P 533319

**ON-SITE SEWAGE DISPOSAL SYSTEM
HOWARD COUNTY HEALTH DEPARTMENT
BUREAU OF ENVIRONMENTAL HEALTH**

ADDRESS: 15751 BUSHY PARK ROAD PROPERTY OWNER: JOHN CLIME

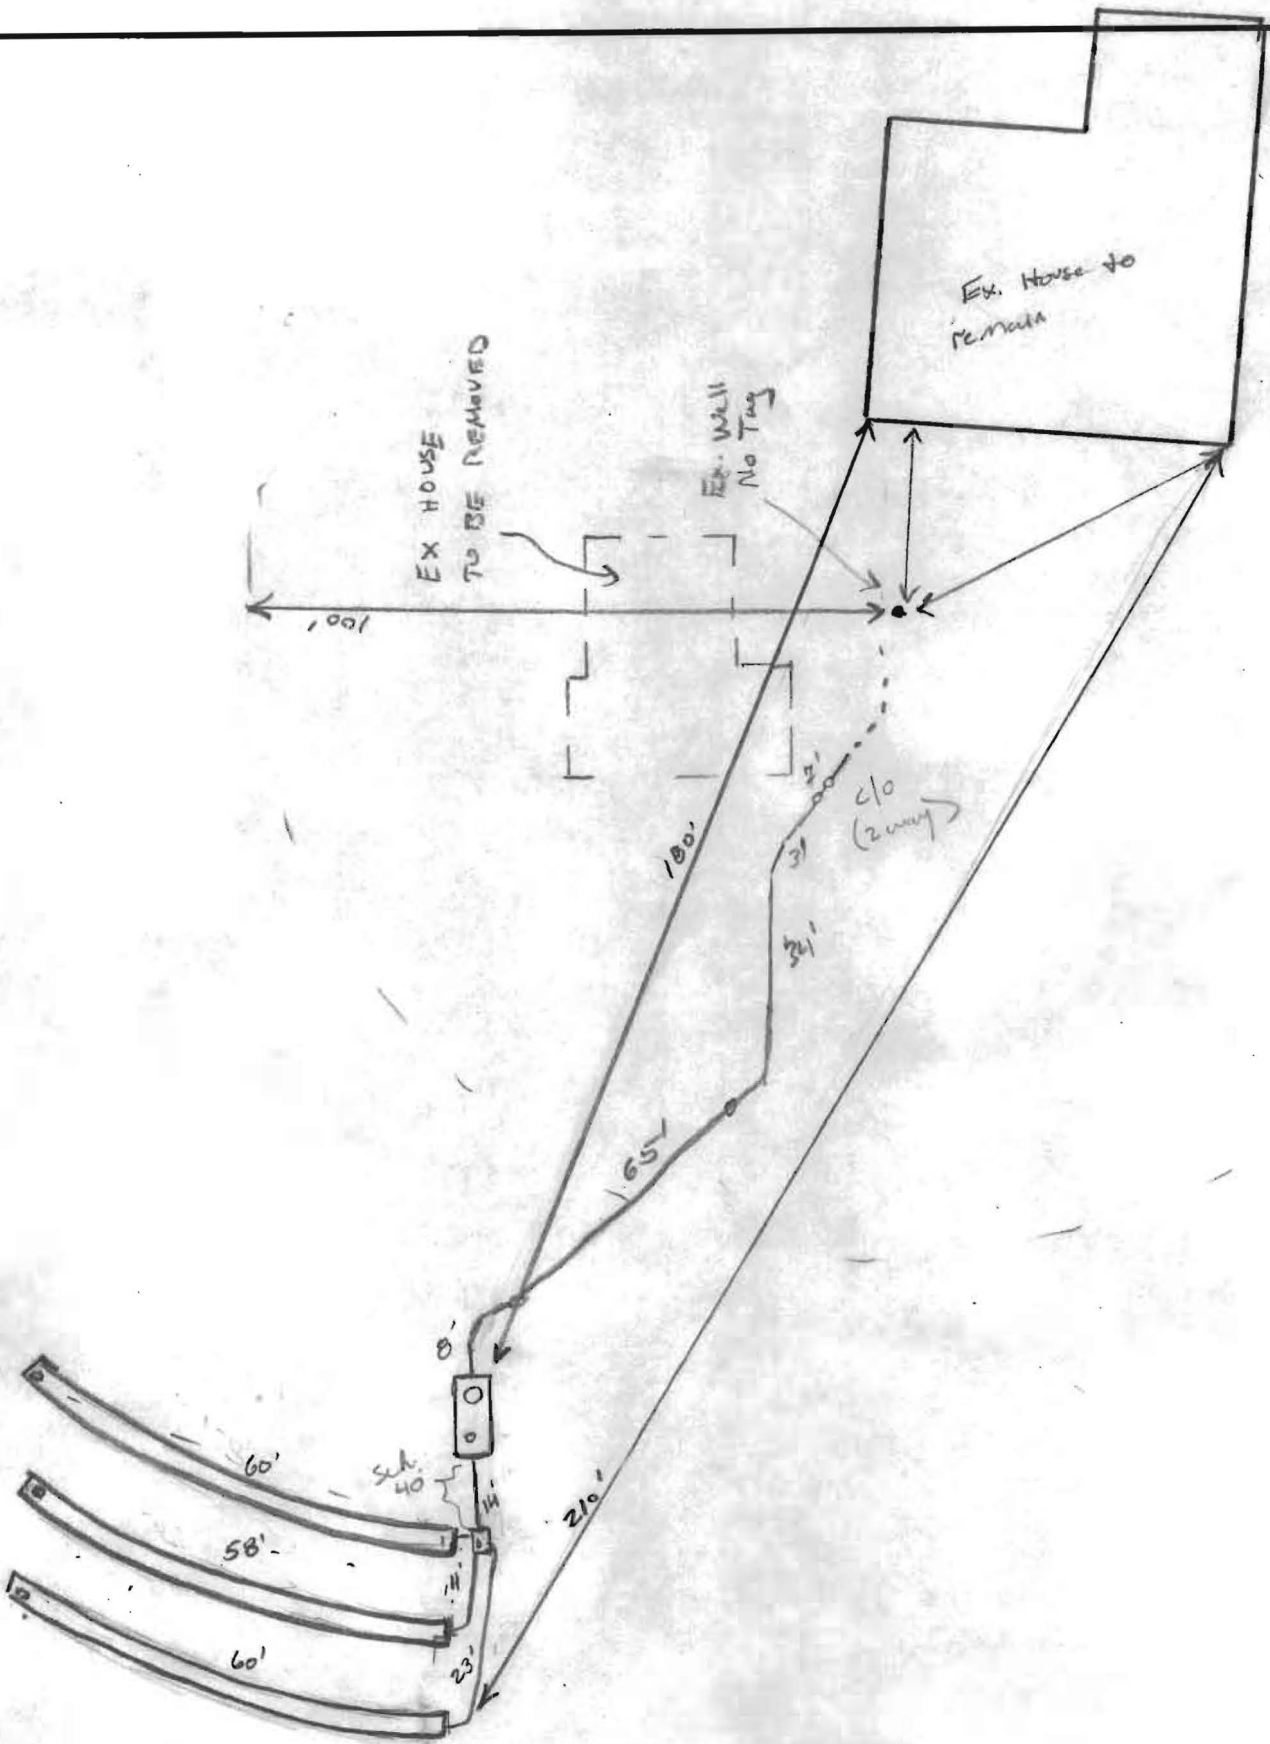
8/2/10 Trench layout given. 30x52' trenches are to be installed on contour starting just above perc test 1002. Set tank gora 15' from Dbox, out of 100' radius of ed. well. Call for inspection. Ex well needs to be raised above final grade min. 8". This can be done after permit. (KW)

INSTALLATION: 8/9/10 Trenches installed. Digging tank hole now. Told me to keep hole shallow (check dimensions). OK to backfill trenches. Leave Dbox network exposed when installed. (KW)

8/12/10 Tank set, baffles installed correctly, tank level. Dbox installed but not leveled. Contractor installed "bells" in pipe to trenches backwards. Reverse bell or add coupling and cut out bell and call for re-insp. 8/13/10 Couplers added. Bells switched around. Dbox leveled. Need S.H.C. (KW)
